## Entry Step Ignition Lockout

<b>Bulletin Type:</b>	TSB	<b>Publication Date:</b>	June 2025
<b>Bulletin #(s):</b>	25-012	<b>Make(s):</b>	Jayco & Entegra Coach
<b>Job Code(s):</b>	9803632	<b>Model(s):</b>	Condor (23S) Granite Ridge (23S)
<b>Flat Rate(s):</b>	9803632 1.0 HR Entry Step Ignition Repair	<b>Model Year(s):</b>	2025 - 2026

<b>Incident:</b>	Entry Step Ignition Lockout not connected.
<b>Affected Units:</b>	2025 Jayco Granite Ridge & 2025 - 2026 Entegra Coach Condor
<b>Parts Kit: 25-012JM</b>	Parts Kit #: 25-012JM
	1 - CONNECTOR,SPLICE 12-24GA 3 WIRE CLR PLSTC WAGO MFR# 221-413
	1 - FUSE,10AMP ATC/ATO-10 SPADE (Jayco Part #0052231)
	4 - TIE,CA 14.00" BLK
	1 - HOLDER,FUSE IN-LINE 24"
<b>Misc. Tools &amp; Supplies:</b>	3-Way Wagos Wire Cutters Torque Wrench with E12 Torx Socket
<b>Parts Return Information:</b>	N/A

## ENTRY STEP IGNITION REPAIR INSTRUCTIONS

Fig. 2

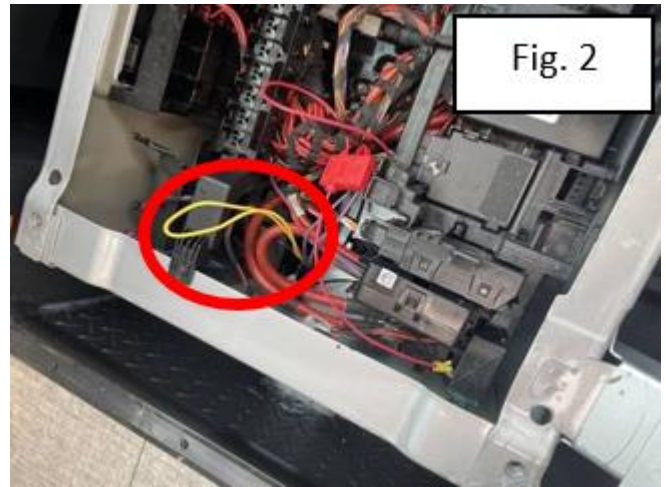
2. Locate the 16AWG Yellow wire under the driver side seat base. (Figure 2)
3. Locate the red wire under the driver side seat base with the inline fuse (10A) and blue terminal ring. The wire needed, will be on the left-hand side. (Figure 3)

Fig. 4

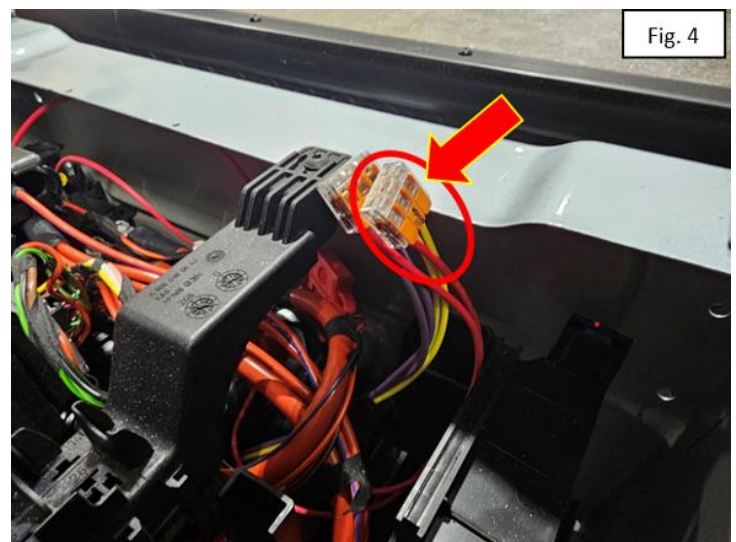
4. If the 16AWG yellow wire is looped, it will need to be cut and a wago connector added in with the red wire from the in-line fuse holder (10A), with the blue terminal ring. (Figure 4)
5. When re-installing front OEM seats to the seat base:
  - A. Using an E12 Torx Socket, re-install and tighten.
    - a. **Note: Seat Bolts should be finger started to prevent cross-threading.**
